Title - Sujet Storage Cabinets	
Solicitation No. - N° de l'invitation G1822-120054/A	Amendment No. - N° modif. 005
Client Reference No. - N° de référence du client G1822-120054	Date 2013-04-15
GETS Reference No. - N° de référence de SEAG PW-\$MCT-011-4617	
File No. - N° de dossier MCT-2-35128 (011)	CCC No./N° CCC - FMS No./N° VME
Solicitation Closes - L'invitation prend fin at - à 02:00 PM on - le 2013-04-19	Time Zone Fuseau horaire Atlantic Daylight Saving Time ADT
F.O.B. - F.A.B. Plant-Usine: <input type="checkbox"/> Destination: <input checked="" type="checkbox"/> Other-Autre: <input type="checkbox"/>	
Address Enquiries to: - Adresser toutes questions à: Sharpe, Charlene A.	Buyer Id - Id de l'acheteur mct011
Telephone No. - N° de téléphone (506) 851-3467 ()	FAX No. - N° de FAX (506) 851-6759
Destination - of Goods, Services, and Construction: Destination - des biens, services et construction:

Solicitation Amendment No. 005

This solicitation is hereby amended to provide the following questions and answers

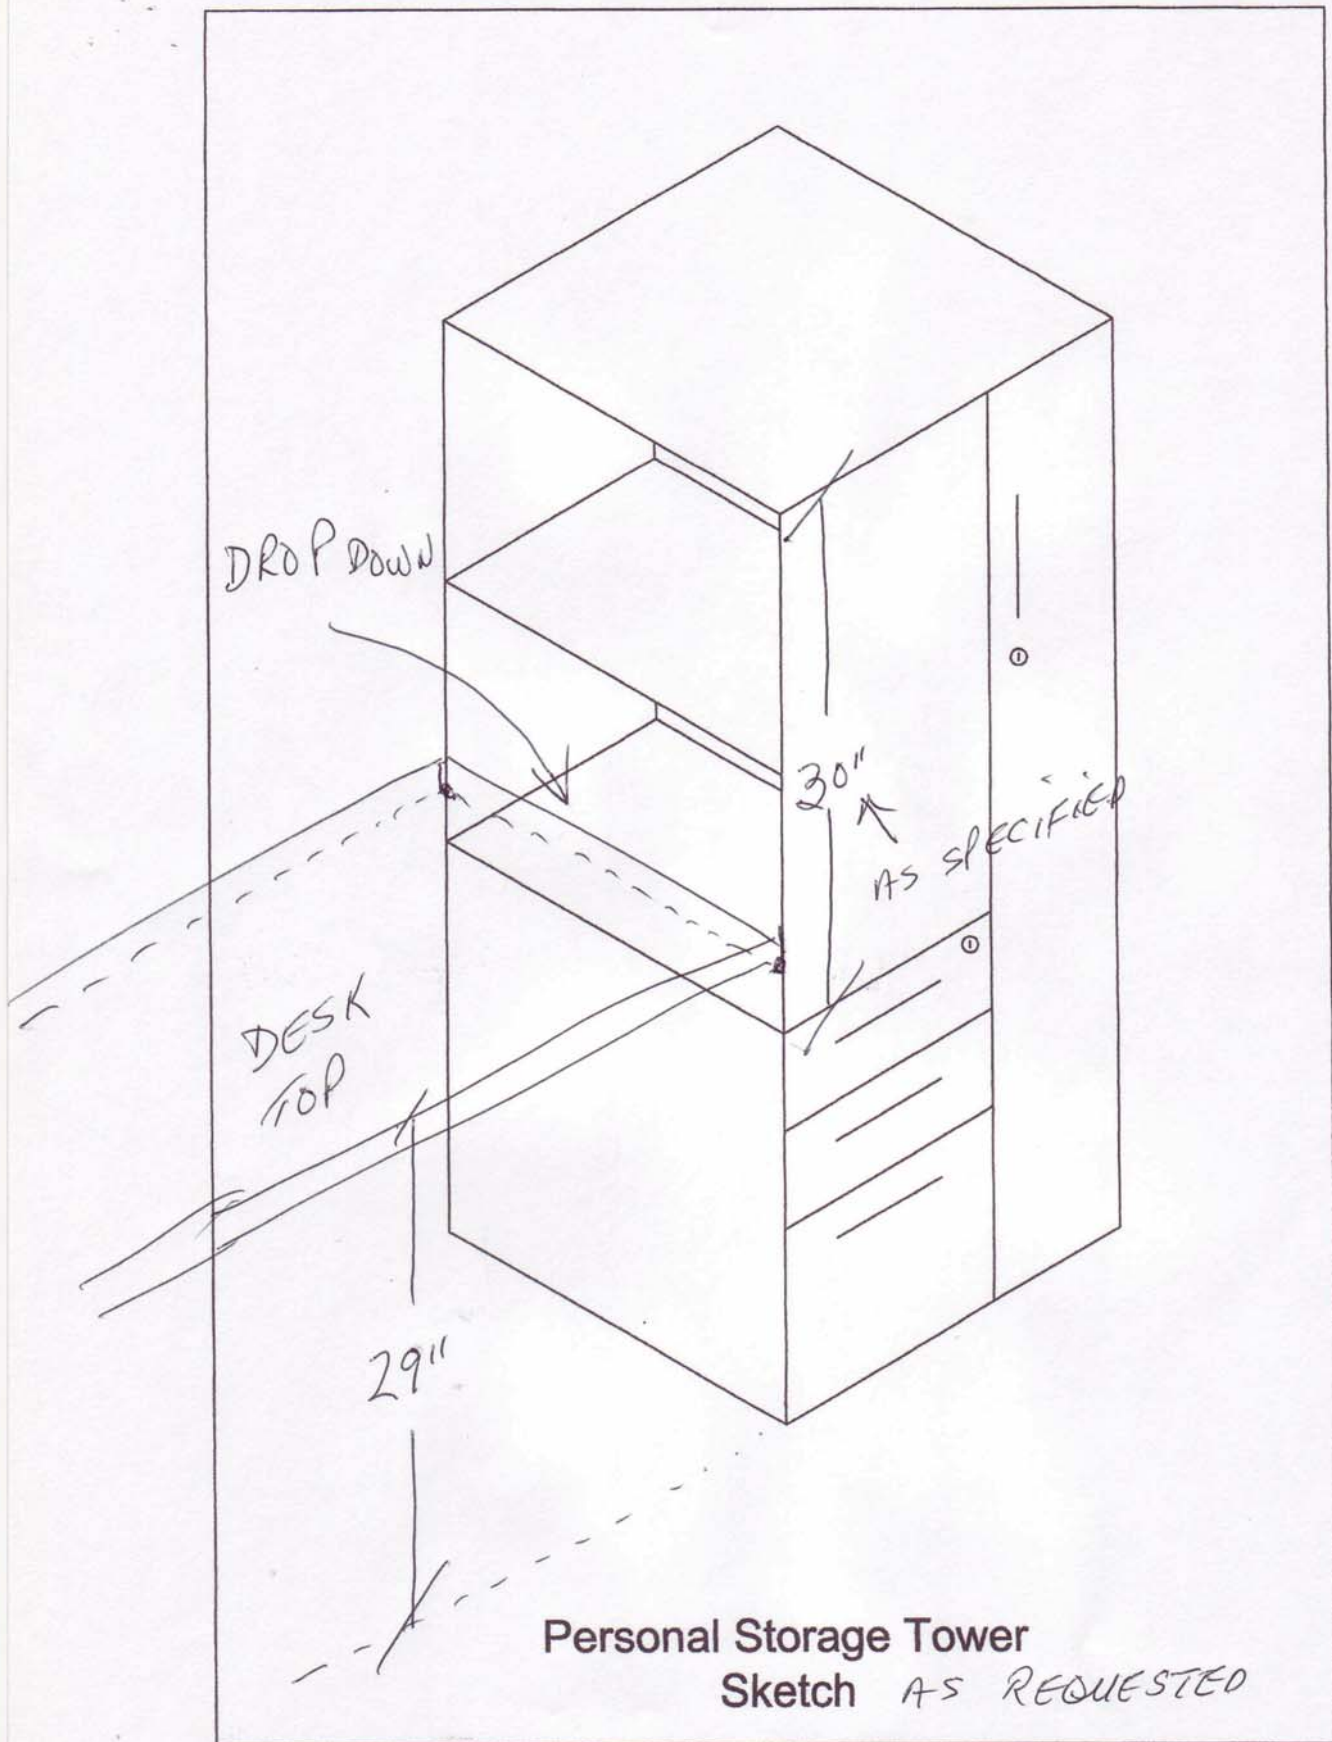
Q1. We can provide the dimensions you have requested in your tender; however, based on the maximum height of 56" and if the 30" external minimum height for the bookcase is used, that would leave only 26" for the lower drawers as well as the base. It would also mean that the lower shelf would actually be below the standard work surface height of 29" and could cause injury to an employee who may have to lift out a heavy binder from the cavity (see attached sketch for a visual glance)

The actual maximum External shelf dimension should be 28.7 inches from top of cabinet to the top of the lower shelf. That would leave the bottom of the shelf at the same level as the adjacent work surface which is 29" Standard. I have also attached a standard cabinet sketch with dimensions that could work

A1. Very good observations! You are correct by stating that the upper bookcase, if at 30" external minimum height, would create a low bookcase surface area. The top of the bookcase shelf adjacent to our work table shouldn't be much lower than our standard work surface height of approximately 29". This is something that we want to avoid for numerous health and safety and operational reasons.

I guess we have not taken into consideration the thickness measurement of the cabinet base or the thickness measurement of the top element above the 3 drawers within our initial calculation approach of requesting a 30" bookcase opening.

Therefore it would be safe to say that the bottom of the bookcase should start at approximately 29" from the floor and still be able to accommodate the 3 drawer's specifications, the cabinet base as well as the overhaul required storage tower height of 54" to 56".

The ideal situation is to be able to accommodate two rows of regular binders high within the bookcase overhaul opening height without going any higher than with a 54" or 56" high tower and without going lower than the 29" starting point.
